Applicant's Data Responses Set 3A (Nos. 186-190)
for the **APPLICATION FOR CERTIFICATION**
for the **Rio Mesa Solar Electric Generating Facility**
(**Rio Mesa SEGF**)

Subject: Applicant's Data Responses Set 3A (Nos. 186-190)
Rio Mesa Solar Electric Generating Facility (11-AFC-04)

Applicant's Response to Data Requests, Set 3A (Nos. 186-190)

**Rio Mesa Solar Electric
Generating Facility
(Rio Mesa SEGF)**

**34TH AVENUE ACCESS ROAD
RIO MESA SOLAR
ELECTRIC GENERATING FACILITY**

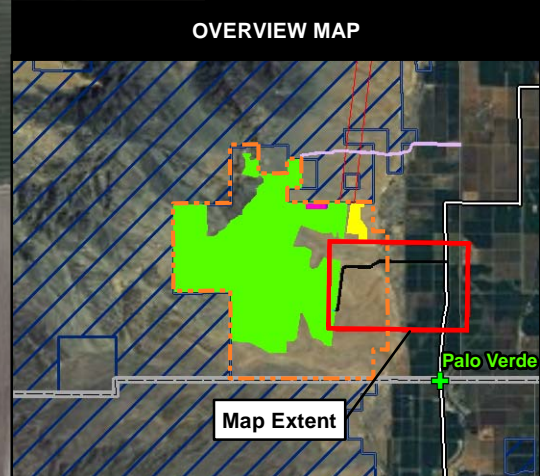
186. *Please provide a map of the proposed 34th Avenue access (secondary access) showing the exact location of the County ROW and any public or private easements, the location and type of any project access improvements, and property ownership (County, private, BLM, etc.) of the land on which improvements would occur. This map should commence at the connection of State Route 78 to its termination within the project site.*

The attached Figure 1 depicts the entire extent of the 34th Avenue access road improvements, from the connection at State Route 78 to the termination within the project site. The entire access road will be located on private lands. There are no existing easements along the access road through Section 24, Township 8 South, Range 21 East. The Riverside County, 60-foot wide right-of-way (ROW) ends at the western Boundary of Section 24 and is located south of and abutting the proposed project access road ROW. The project access road will be constructed in accordance with applicable County road and safety standards.
